# THE SYDNEY CBD SOUTH EAST LIGHT RAIL (CSELR): RESPONSE TO ENVIRONMENTAL IMPACT STATEMENT

BY TONY PRESCOTT

5 DECEMBER 2013

Figure 2: Stop with split (offset) side platforms

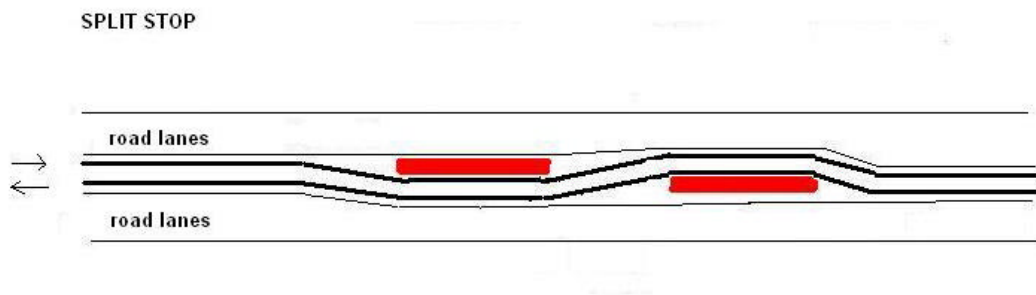
The recent upsurge in use of centre-island platforms on new light rail systems is a result of design by heavy rail expertise with no understanding of tramway operation, a desire to save construction cost and pressure by road authorities to minimise lateral space encroachment on road lanes. However, there is an alternative that addresses the lateral space issue – the split stop, which has two side platforms longitudinally offset from each other with the tracks slewed around the stops. These can occupy less lateral space than a centre-island platform because a single side platform doesn't need to be as wide as a centre-island platform because it is catering to half the demand.

That smaller total platform footprint of a centre-island (compared to two side platforms) means less space on the platform for a crowd of passengers and having conflicting flows clashing, rather than being separated. The centre island has to handle twice as many people as a side platform, without the advantage of twice as much width, because it is used to reduce lateral width. If a tram in one direction is loading or discharging a particularly large load, a tram in the opposing direction may have to stand off the platform until the crowd clears (observation from Adelaide). This undermines on-time running.

**Key recommendation: All stops be designed to conventional tramway standard, that is, with side platforms, whether facing islands, staggered islands, Vienna stops or stops with platforms incorporated in the footpath.**

Figure 6: Circular Quay loop

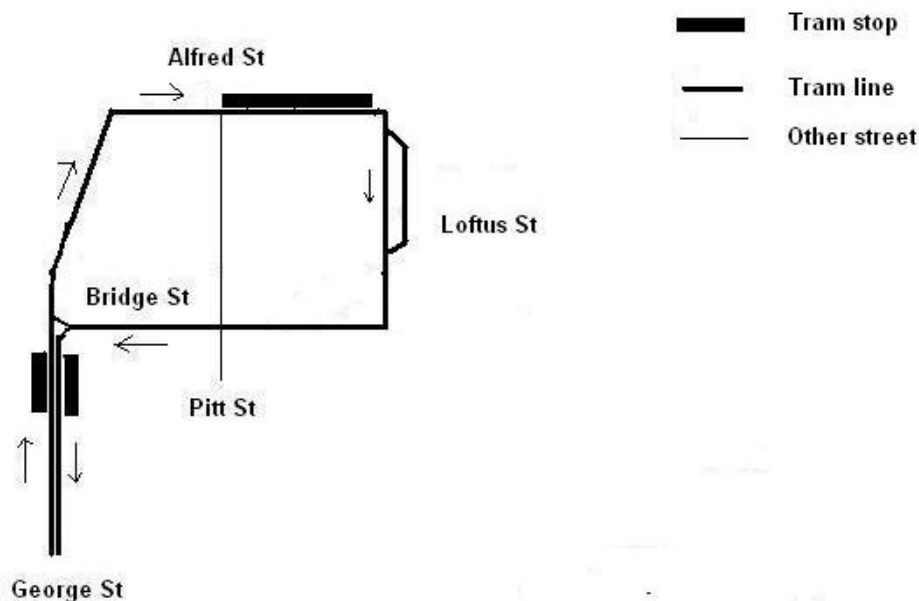
Construction of the line at Circular Quay as a loop is a simple matter, based on the precedent of the former tramway system, the lines of which were all looped at the Quay. North of Bridge Street, the George Street line would become a single track to Alfred Street, into which it would turn to a single long-platform terminus (for at least two trams) at the northern kerb of Alfred Street, alongside the railway station.

This would return more of the Alfred Street space to pedestrian plaza and remove the “railway marshalling yard” appearance created by the present terminus design. Except as described in the next paragraph, there would be no layover at Circular Quay and the trams would loop continuously in and out. The layover (including driver rest breaks) would be at the outer termini.

After leaving the platform, trams would turn into Loftus Street, then Bridge, then back into George. (A shortcut is possible via Macquarie Place if desired.) A siding loop/layover can be provided in Loftus Street to enable any out-of order trams to pass each other, or to hold trams on standby to meet additional needs (e.g. during special events). These trams can return to the Quay on the loop via Bridge and George Streets, back to Alfred Street. In the longer term, a return on the loop can be built via Pitt Street. This would enable more trams to be held in reserve for special events and fed in more quickly.

- The Circular Quay terminus should be redesigned as a loop via George, Alfred, Loftus and Bridge Streets, with a holding siding in Loftus Street (section 4.2.1.1 refers).

Figure 7: Kingsford loop

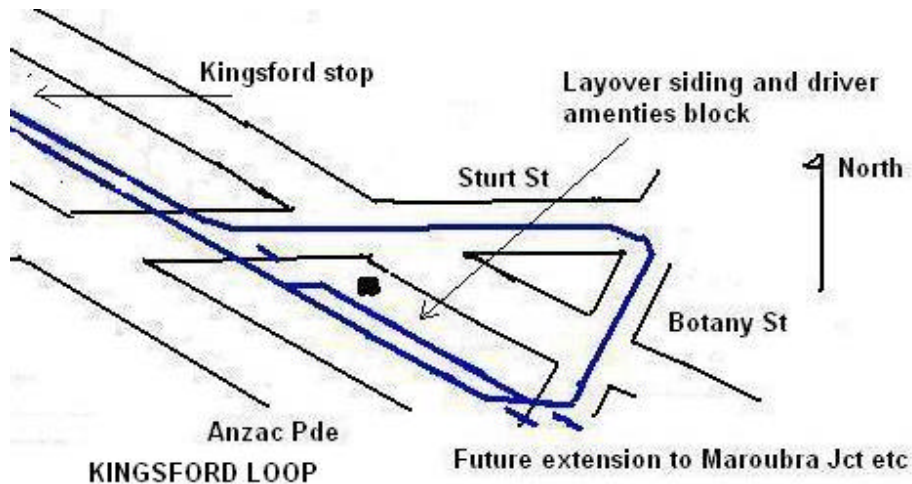
In the future, in the event of a long-distance extension served by unidirectional trams with more seating, in order to short-work UNSW services without reversing, trams can loop via

Sturt and Botany Streets, back to the central reserve between Botany and Sturt Streets. At present, however, this loop would be a low priority.

Figure 9: Randwick loop

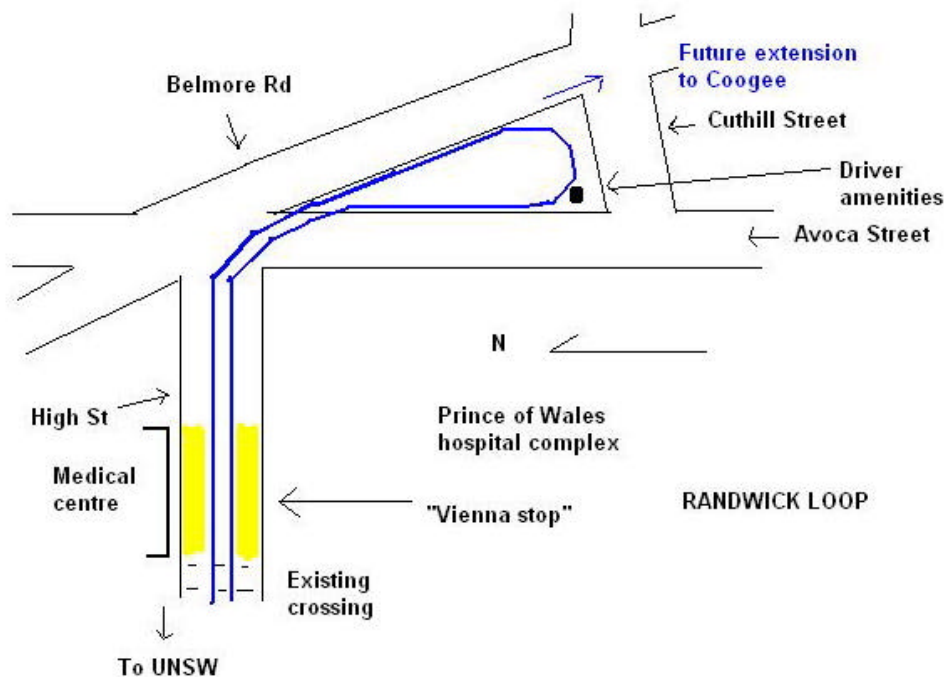
High Cross Park is an ideal site for a loop and layover (with drivers' amenity building), which could be set in grass lawn and not destroy the park, as the present proposal does. It is not the place for a stop – which should be in High Street to directly serve the hospitals and shops – but it is recognised that the initial intention is to provide a bus interchange. However, if the line is extended to Coogee, the need for this interchange should significantly diminish, but the loop can remain as a turning-point, for example for UNSW peak services.

Figure 10: Central Station loop

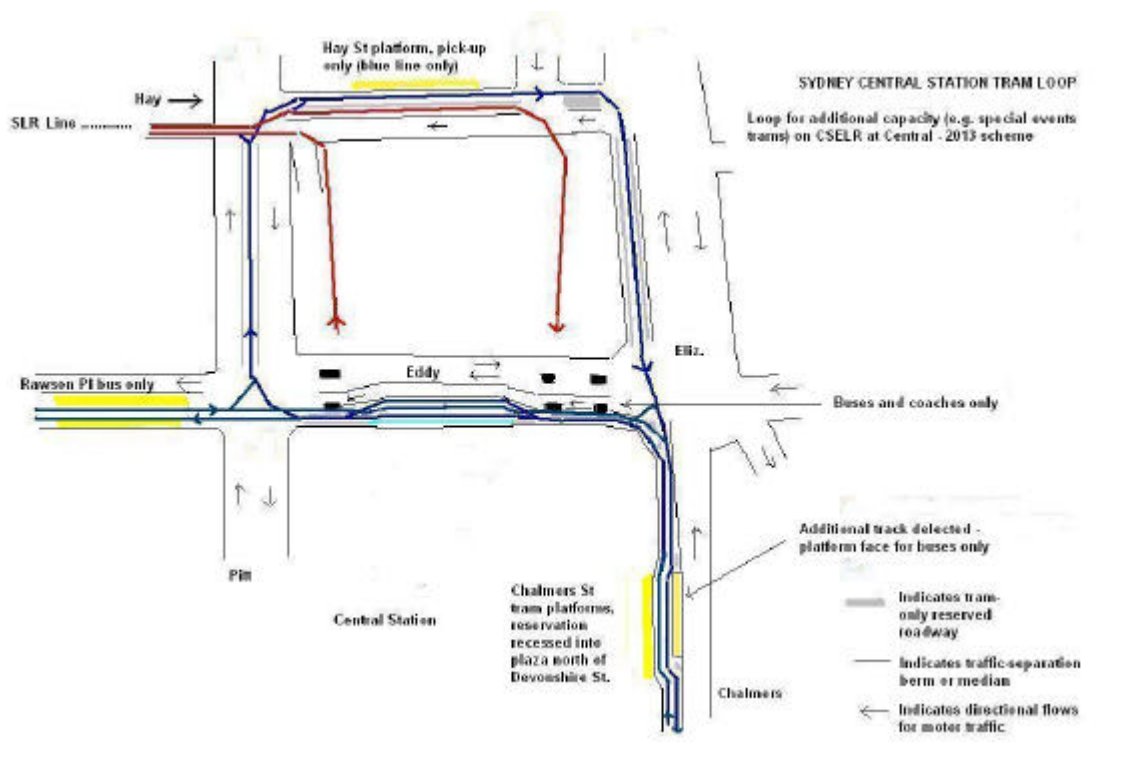
Loops can hold a number of trams on standby that can be fed into the stop as required. Being separated from the service line, trams can be stored around this Central loop (as well as in the Eddy Avenue siding if it is retained). Thus, there is no need for the additional platform face in Chalmers Street (and it can thus be permanently used as a bus stop), as trams can be fed into the stop from the loop immediately, as needed.

As there would be two reserved tram tracks in Hay Street, it is proposed that there be only one traffic lane, westbound on the southern side. There is also scope for connections via this loop to and from the Inner West Light Rail should any through-routing to the south-east be required, as outlined in section 3.1 above. A platform can be incorporated in the footpath on the northern side of Hay Street to serve the loop should it be required in any special circumstances.

**Key recommendation: A special-event turning and holding loop should be built at Central Station, around the streets surrounding the perimeter of Belmore Park.**

Figure 11: Moore Park special events loop and stop

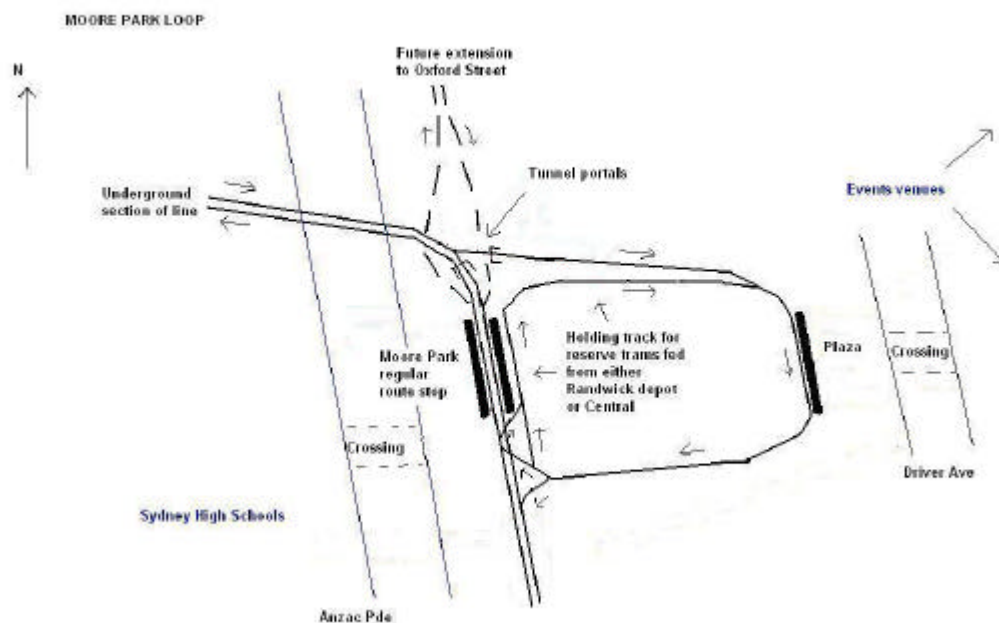
There would be a long (90+ metres) nearside platform on the eastern side of the loop, adjacent to Driver Avenue – merging into the pedestrian plaza and bringing patrons up close to the venues and without having to cross any tram tracks.

The Moore Park regular stop would remain as a stop for the route services only and would serve normal daily needs of the high schools and the entertainment quarter. An overhead pedestrian bridge at the stop would not be needed. That said, an integrated pedestrian/cycle plan for Moore Park generally – including grade-separated crossing of Anzac Parade, logically a subway beside and built in conjunction with the CSELR tunnel – seems necessary in conjunction with the project.

**Key recommendation: A special-event loop, with platform adjacent to Driver Avenue and a holding siding, should be built at Moore Park.**

Figure 12: Randwick racecourse special events loop and stop

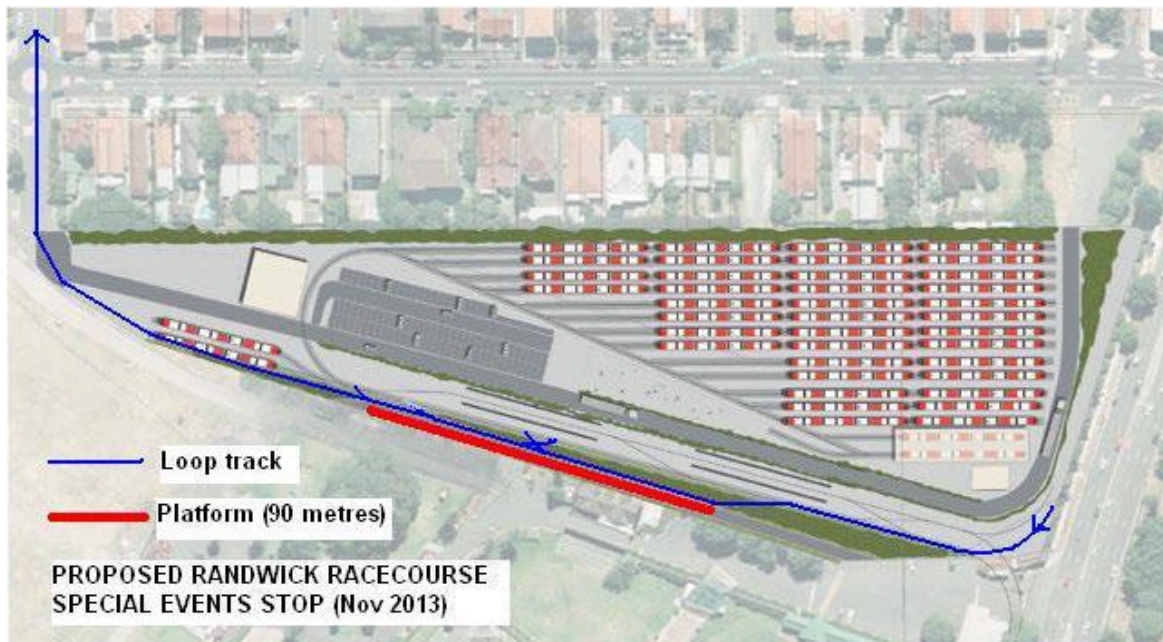
- Using the loop track within the depot fan, return to Alison Road via the westernmost storage track in the depot yard; or
- Follow the former tramway alignment out the Ascot Street gate and along that street to join the Kingsford line in Anzac Parade, Kensington.

The second option is the preferred one as it also offers the advantage of providing direct access to the Kingsford line from the depot so that trams can be dispatched to and returned from Kingsford terminus. The junction of the Ascot Street track and the Anzac Parade tracks would have turnouts in both directions to facilitate this. Under the present arrangement, there is direct access from the depot to the Randwick terminus, but trams to Kingsford have to go along Alison Road to Robertson Road at Moore Park and then reverse down the Kingsford line, a very impractical and time-consuming arrangement.

Minor adjustment would need to be made to the depot trackwork to accommodate this special event stop, but there is room for it and it offers advantages for normal daily dispatching and return of trams as well.
